## HISTORIC AND DESIGN REVIEW COMMISSION

**HDRC CASE NO:** 2019-669  
**ADDRESS:** 1714 S ST MARYS  
1720 S ST MARYS  
1722 S ST MARYS

**TYPE OF WORK:** Construction of a 3-story residential structure, a 4-story residential structure, exterior modifications, rehabilitation

**Historic and Design Review Commission  
Design Review Committee  
Report & Recommendation**

EXISTING EXTERIOR CONDITION  
(WEST ELEVATION)  
SCALE: N.T.S.

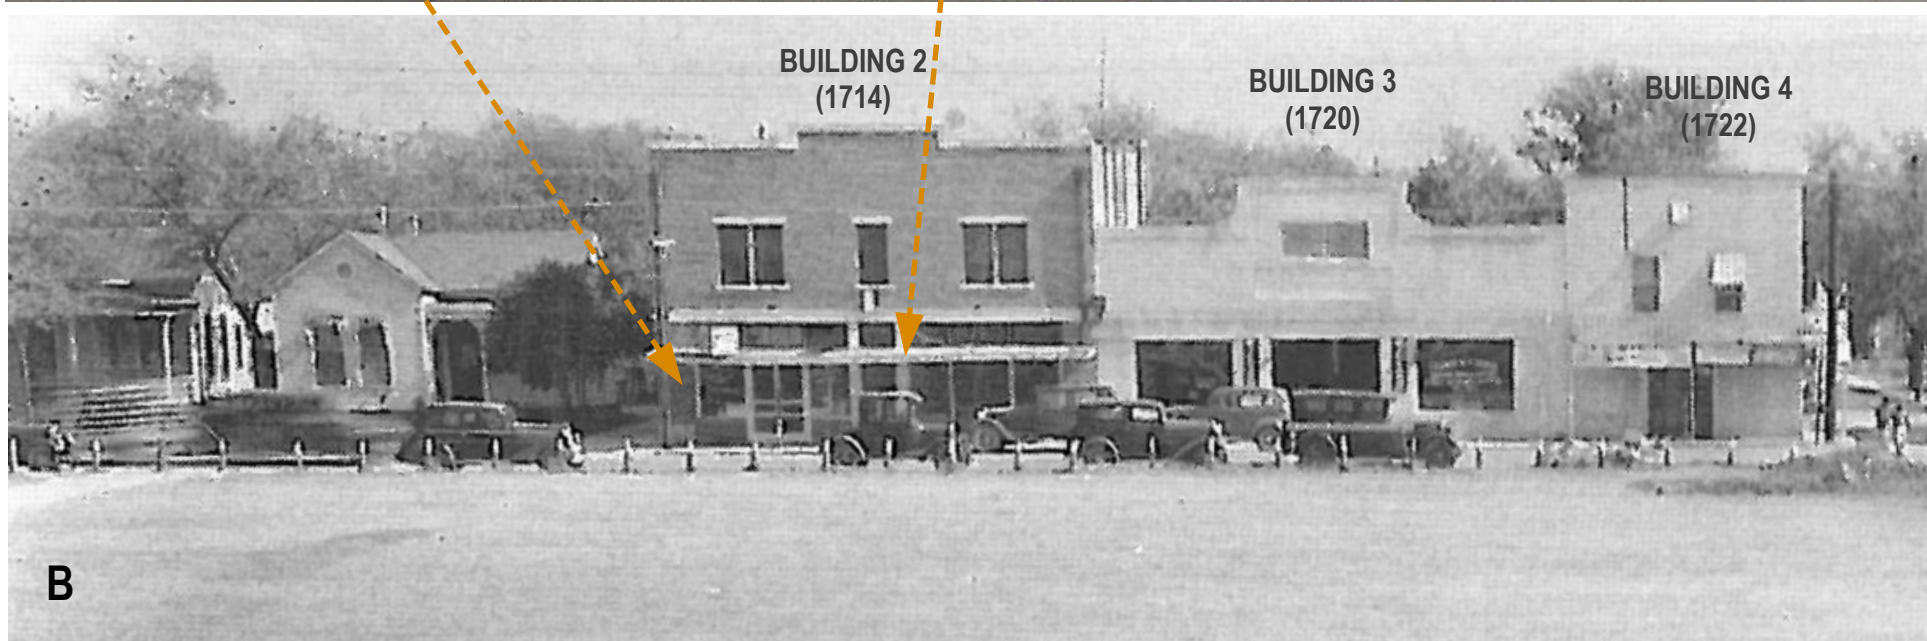
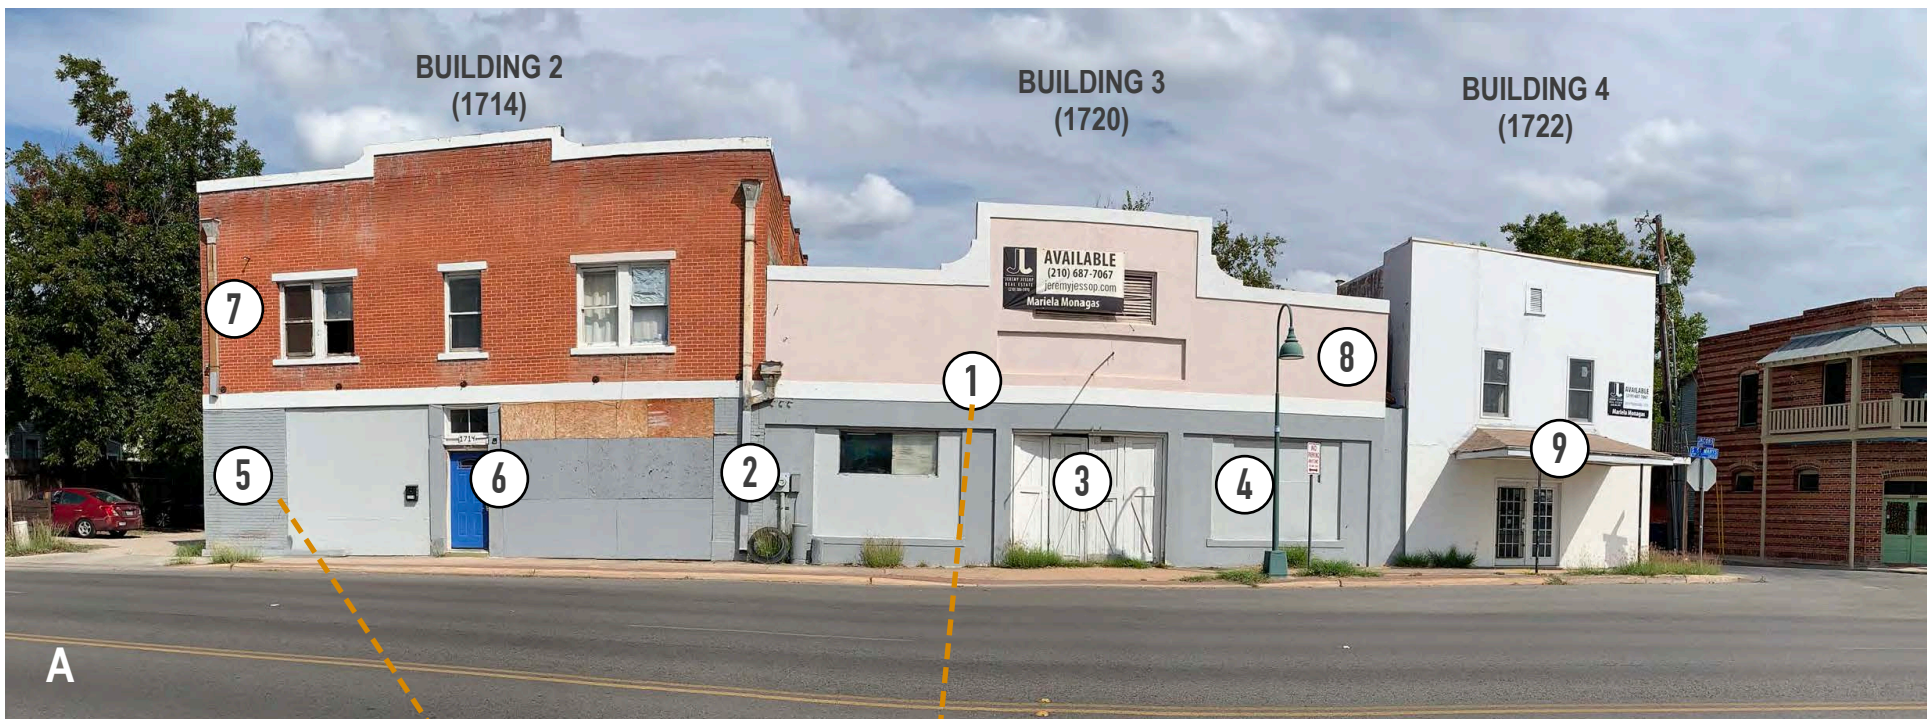
- 1a. PAINT REMOVAL (1714) – The applicant has proposed to remove the paint from the face of the brick on the building at 1714 S St Mary’s. Staff finds the proposed scope of work to be appropriate; however, the paint should be removed in a manner that does not damage the brick.

- 1c. STOREFRONT INSTALLATION, & WINDOWS (1714 & 1720) – The applicant has proposed to install storefront systems into the front facades at both 1714 and 1720 S St Mary’s to replace the previously removed storefront systems, and into the rear façade at 1714. The applicant has noted a metal storefront system at 1714, metal and wood doors, and fixed windows at 1720. The applicant has provided a historic photo noting that the proposed storefront systems are designed based off of the original. The Guidelines for Exterior Maintenance and Alterations 10.B.ii. notes that non-historic facades should be returned to the original based on photographic evidence. Generally, staff finds this to be appropriate; however, the applicant should ensure that the proposed head and sill heights are as historically accurate as possible. Additionally, the proposed knee wall at 1720 should match that noted in the historic photo and be plaster, not brick. The applicant is to submit detailed construction documents and storefront, window and door specifications, including materials and installation depths when returning to the Commission for final approval.

- 1e. STOREFRONT OPENING MODIFICATION (1714) – The applicant has proposed to modify the existing storefront system opening by removing a portion of the brick to create an equally sized opening. Per the submitted historic photos, the applicant would be returning the storefront to its original condition by removing this portion of brick. The Guidelines for Exterior Maintenance and Alterations 10.B.ii. notes that non-historic facades should be returned to the original based on photographic evidence. Generally, staff finds this to be appropriate; however, the applicant is to submit detailed construction documents of this modification for review when returning to the Commission for final approval.

- 1f. CANOPY (1714, 1720, 1722) – The applicant has proposed to install a new street canopy on 1714 and 1720 S St Mary’s, and to replace the existing canopy at 1722). The Guidelines for Exterior Maintenance and Alterations 10.B.ii. notes that non-historic facades should be returned to the original based on photographic evidence. Additionally, per the Guidelines for Exterior Maintenance and Alterations 10.B.ii. notes that canopies and awnings should be added based on accurate evidence of the original, such as photographs. If no such evidence exists, the design of new canopies and awnings should be based on the architectural style of the building and be proportionate in shape and size to the scale of the building façade to which they will be attached. Generally, staff finds this proposed canopies to be appropriate; however, the applicant is to submit construction documents noting the profile and details of the proposed canopies when returning to the Commission for final approval.

- i. That the existing paint be removed in a manner that does not damage the historic brick.
  - ii. That the applicant ensure that the proposed head and sill heights of the new storefront system are as historically accurate as possible. The proposed knee wall at 1720 S St Mary's shall match that noted in the historic photo and be plaster, not brick. The applicant shall submit detailed construction documents and storefront, window and door specifications, including materials and installation depths when returning to the Commission for final approval.

- iv. That the applicant submit detailed construction documents for the proposed storefront width modification for review when returning to the Commission for final approval.

- v. That the applicant submit construction documents noting the profile and details of the proposed canopies when returning to the Commission for final approval.
